DRC Meeting Minutes Monday, May 02, 2022 Zoom (Remote) Meeting

<u>Public Hearing - Site Plan Review and Groundwater Protection Special</u> <u>Permit – Proposed Milford Regional Hospital Medical Facility, 86 Holliston</u> Street

<u>Sign Design Review – Proposed Milford Regional Hospital Medical Facility,</u> 86 Holliston Street

LANDSCAPING

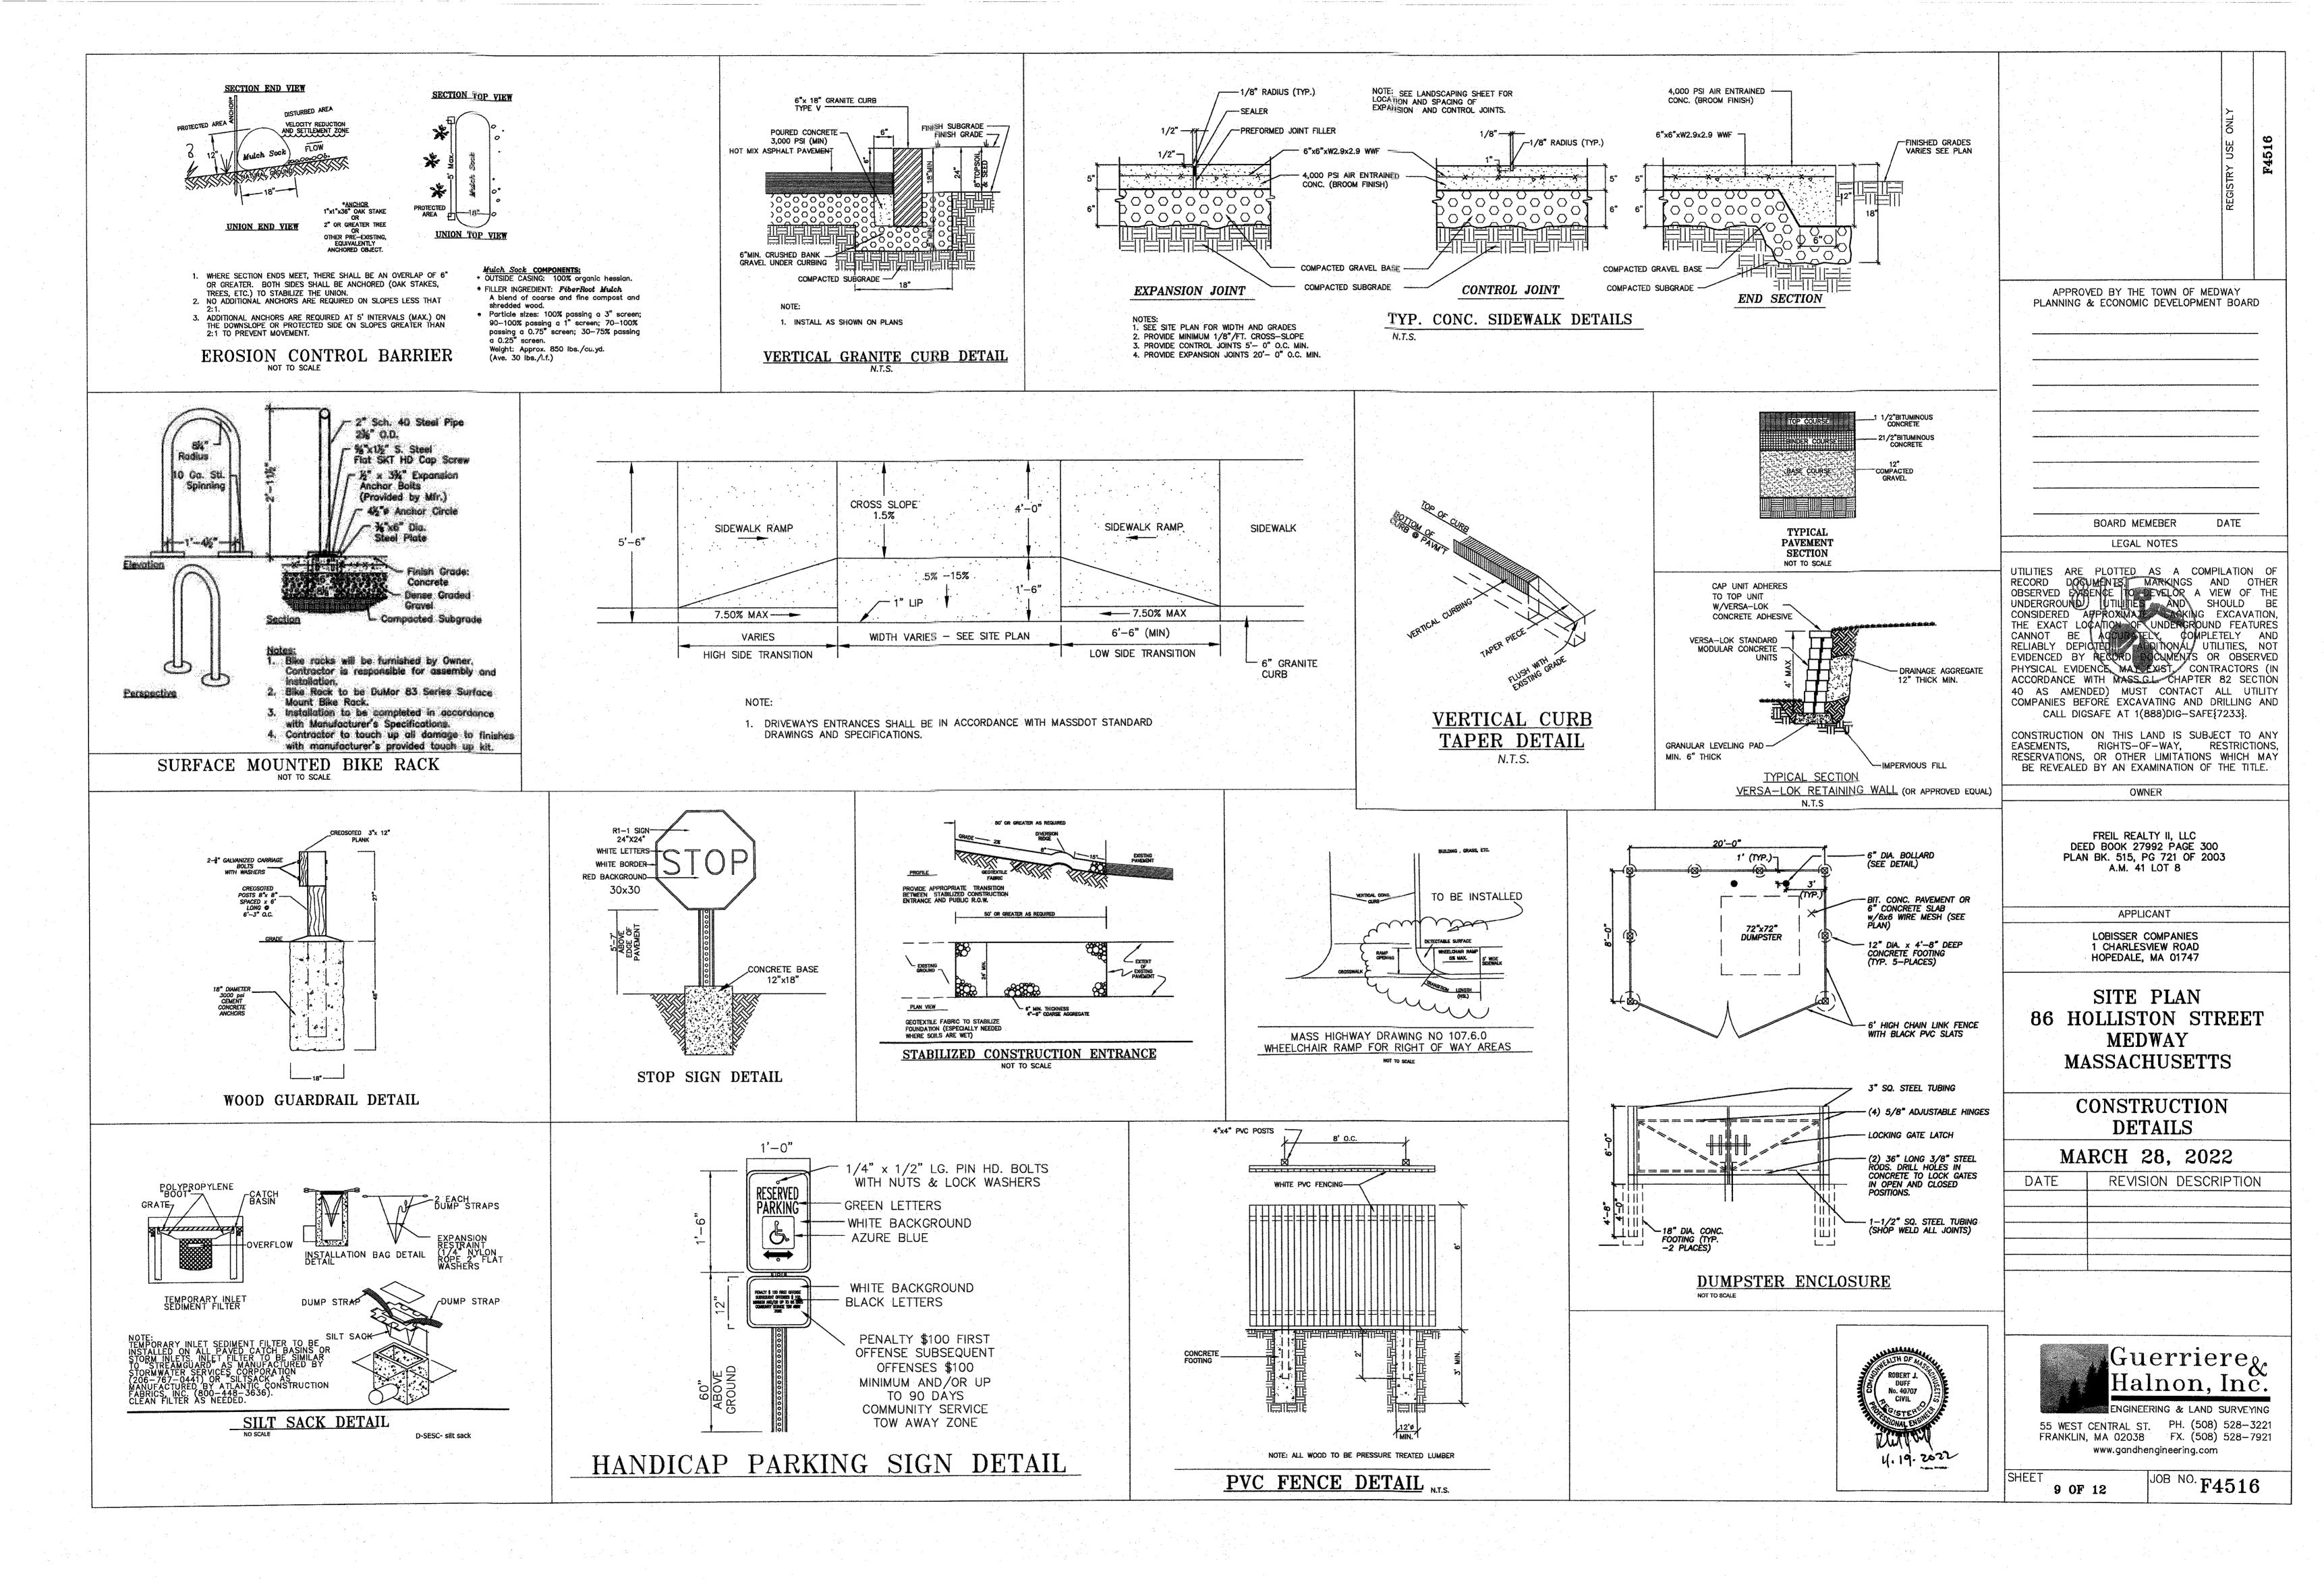
Comment was made to create a pedestrian friendly access to the building entrance by moving the planting island (P2 on the plan), so it aligns better with the entrance and potentially create a sidewalk that comes off Main Street. Response was that grading might be an issue to consider that option. Trellises with climbing vegetation was suggested as a treatment for the east façade.
